**KNOXVILLE HISTORIC ZONING COMMISSION
STAFF REPORT - CERTIFICATE OF APPROPRIATENESS APPLICATION**

PROPERTY ADDRESS: 1019 Eleanor St 37917

FILE NO.: 8-B-18-HZ

LEVEL OF WORK: Level II. Modify existing COA for accessory structure - POSTPONED FROM AUGUST 18, 2018 HZC MEETING

1019 Eleanor - New garage with faux-grained fiber cement board siding (photo provided by applicant)

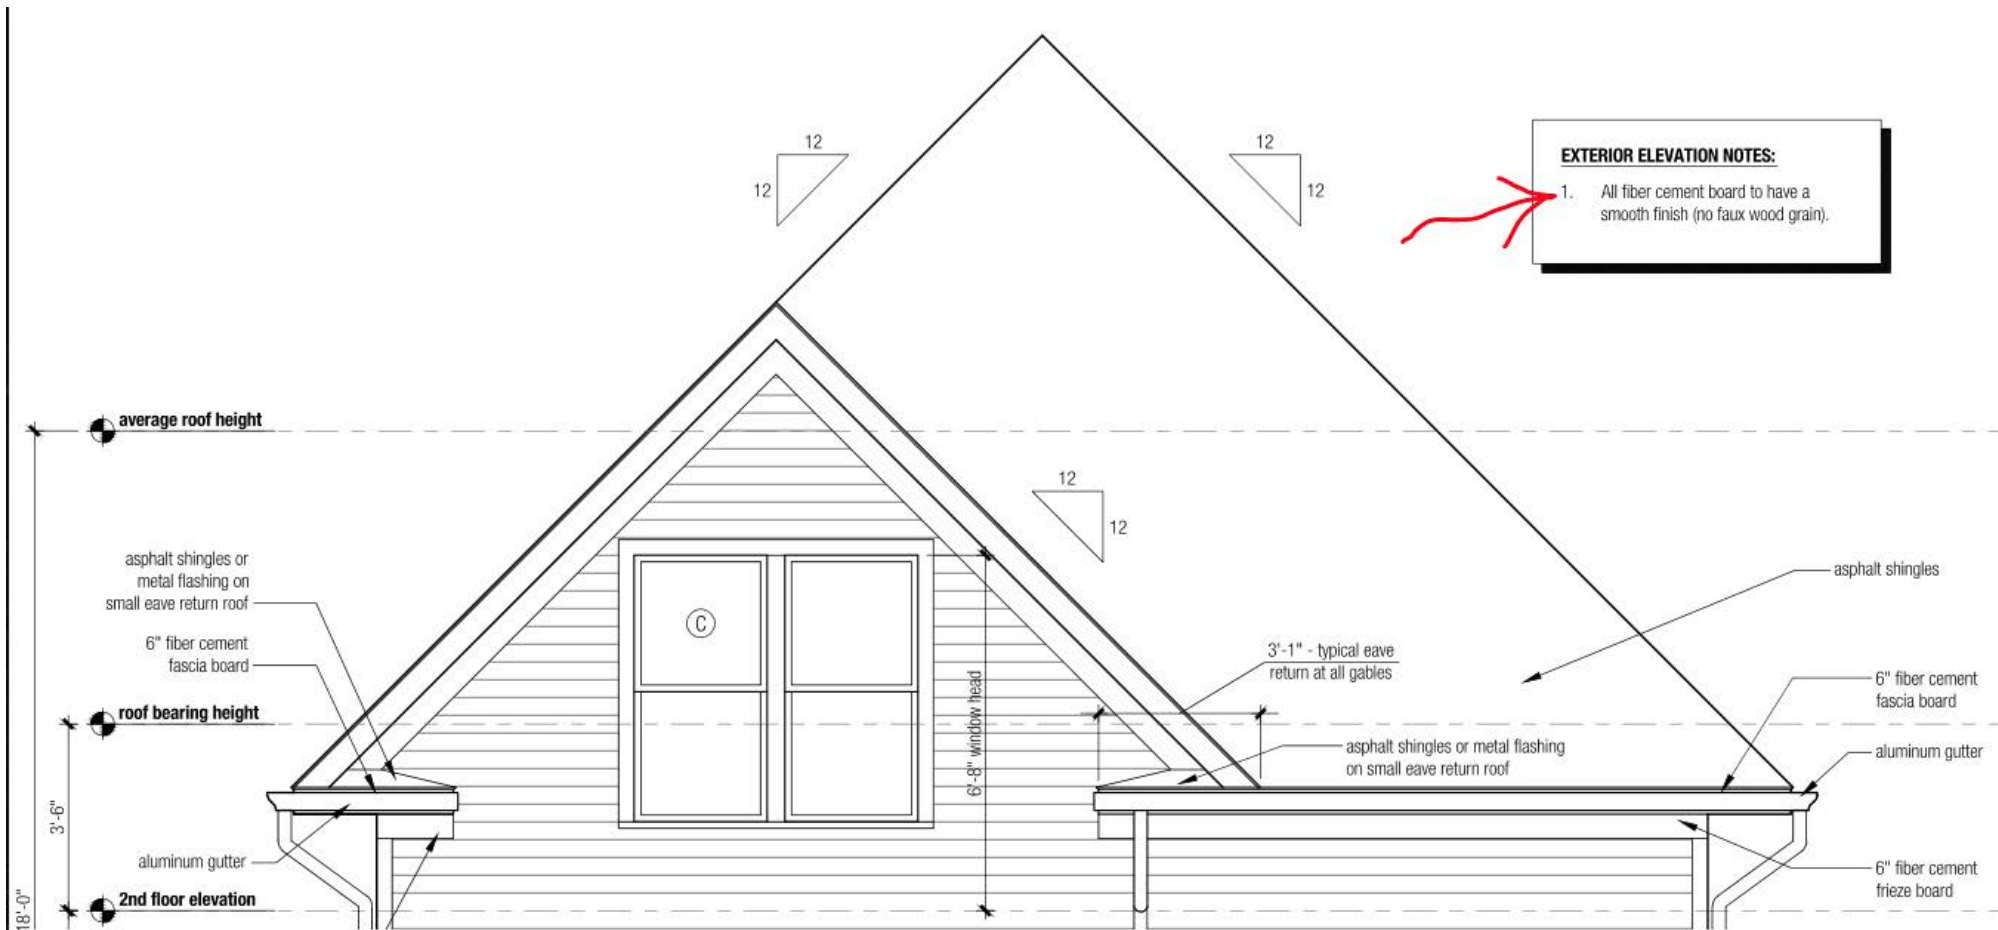
6) The faux-grained fiber cement board siding does not altogether simulate wood texture and visual qualities because the grain is very pronounced and has a shiny appearance.

9) The current FCB siding on the new garage at 1019 Eleanor has two coats of a satin-type finish paint. A flat paint-coat may somewhat mitigate the texture and shine issues of the faux-grained FCB siding.

If the Fourth and Gill Neighborhood agrees to permit the use of the faux-grained finish for FCB in the Fourth and Gill H-1, staff's opinion is that it should be limited to NEW structures that are ACCESSORY only. If the neighborhood desires to maintain and uphold the 6-year precedent for SMOOTH-finished FCB, then the faux grain on the garage at 1019 Eleanor should be mitigated by repainting with a third coat or until the grain is less pronounced, or by replacement with smooth finish fiber cement board as originally approved.
